DEVELOPMENT REVIEW BOARD  
SUPPLEMENTAL SUBMITTAL

PROJECT NO. PR-2018-001284  
Application No. SI-2021-01962

**Re:** Markana Uptown Site Plan Amendment DRB Comment Responses (PR-2018-001284)

This memo outlines the responses and changes made to the site plan for the proposed addition of a 103-space temporary parking lot based on the comments received and reviewed at the December 15, 2021 DRB meeting.

**L1**  
**LANDSCAPE PLAN**

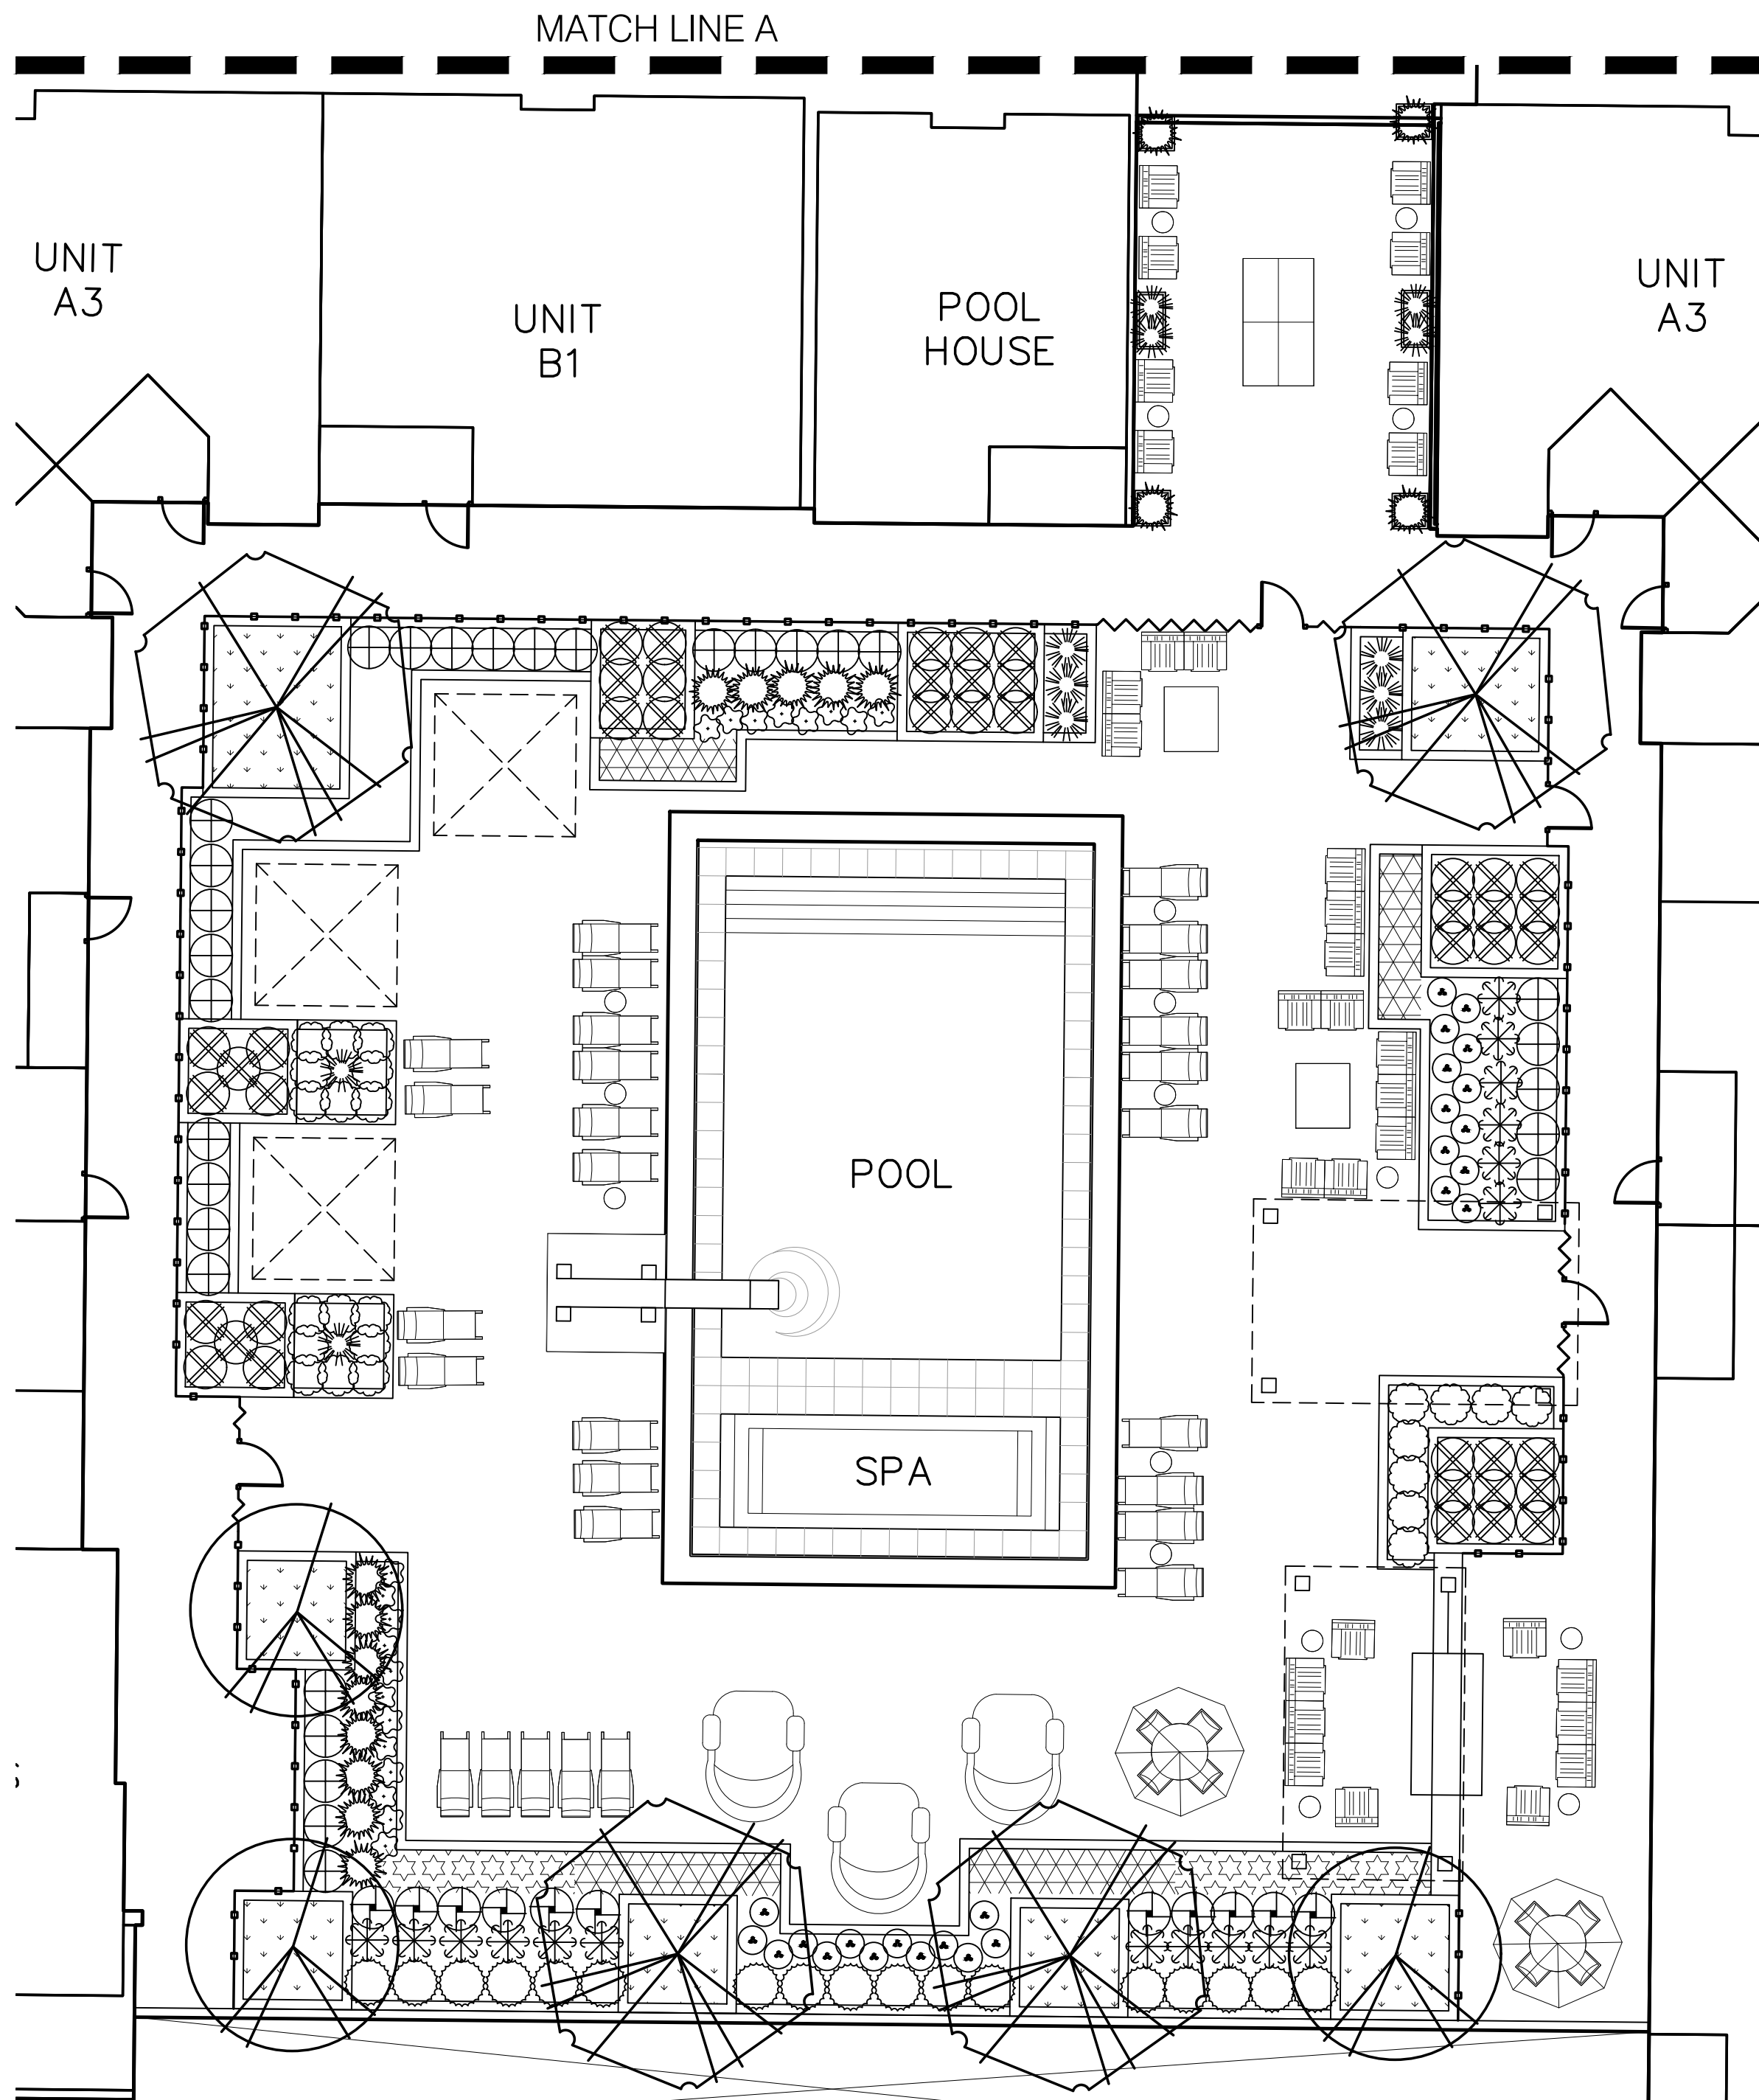
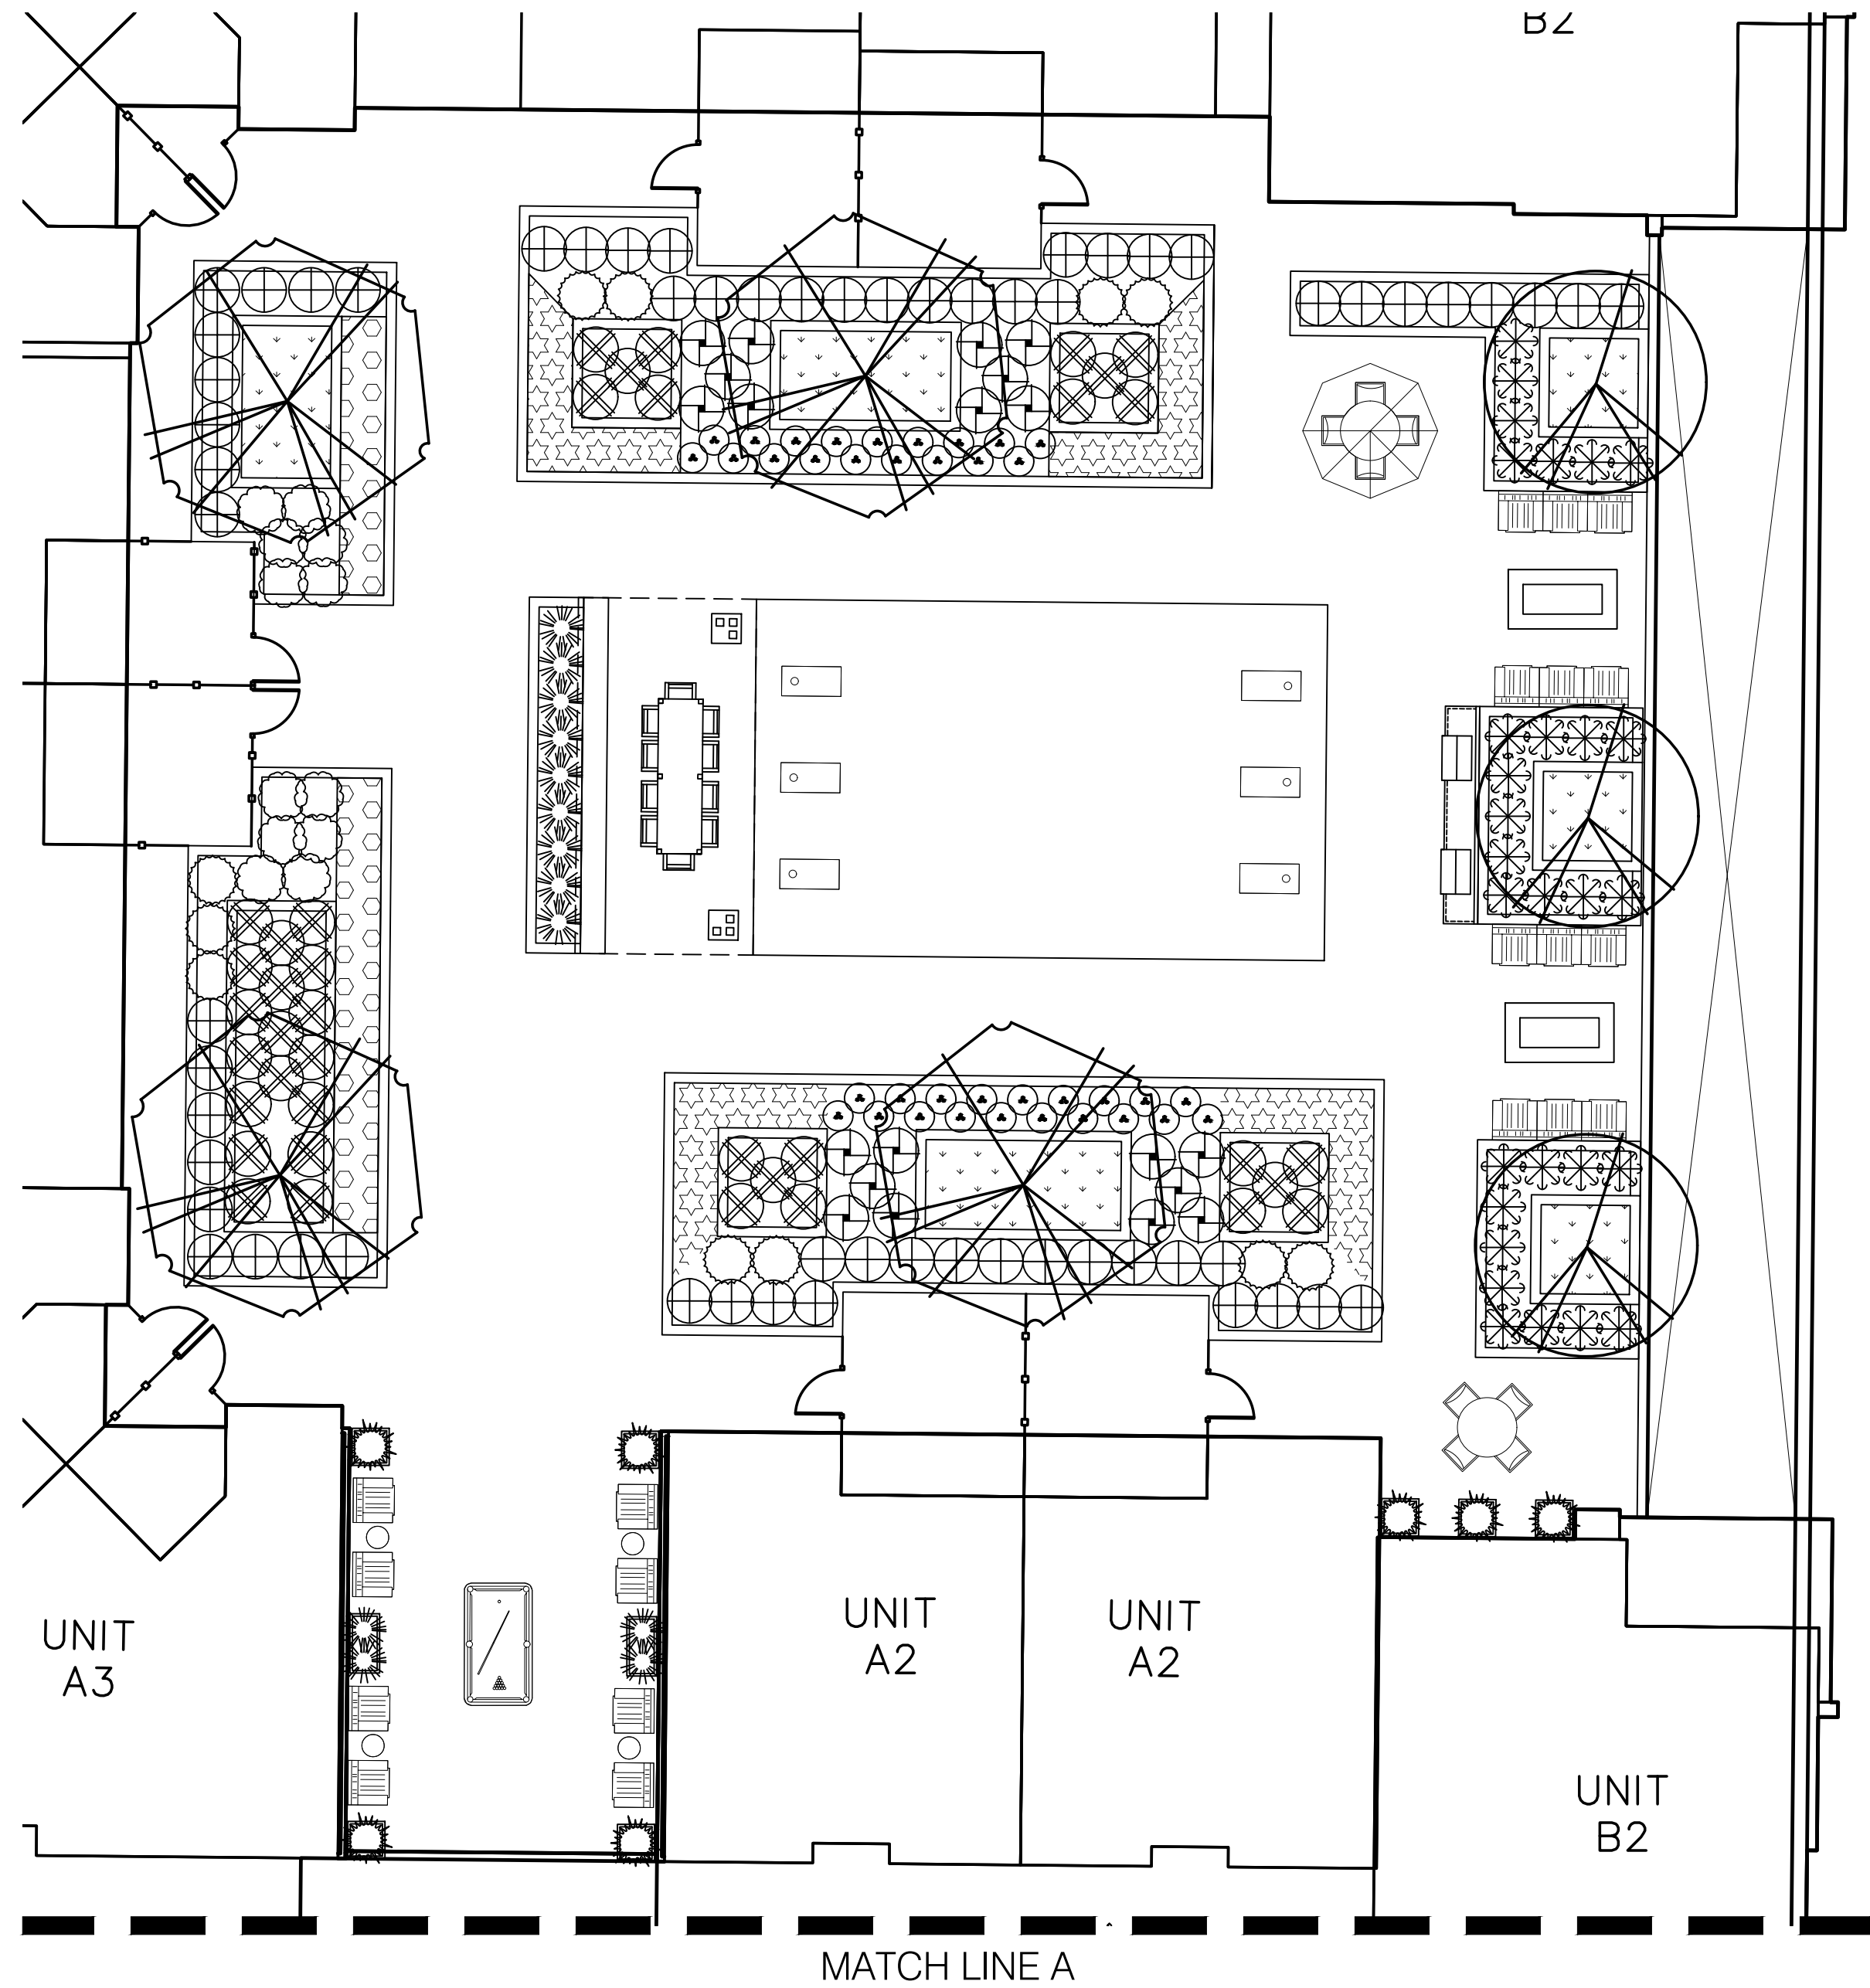
6. The Landscape Plan sheet states that the parking lot landscaping requirements are being met, but it's unclear to staff how those requirements are being met. Please detail which trees are included in the parking lot landscaping requirement.

- a. *The landscape plan has been updated to identify the parking lot trees with the designation "PLT" at each symbol.*
7. Confirm if there's a dumpster in the parking lot. If there is, Solid Waste approval and their signature will be required.
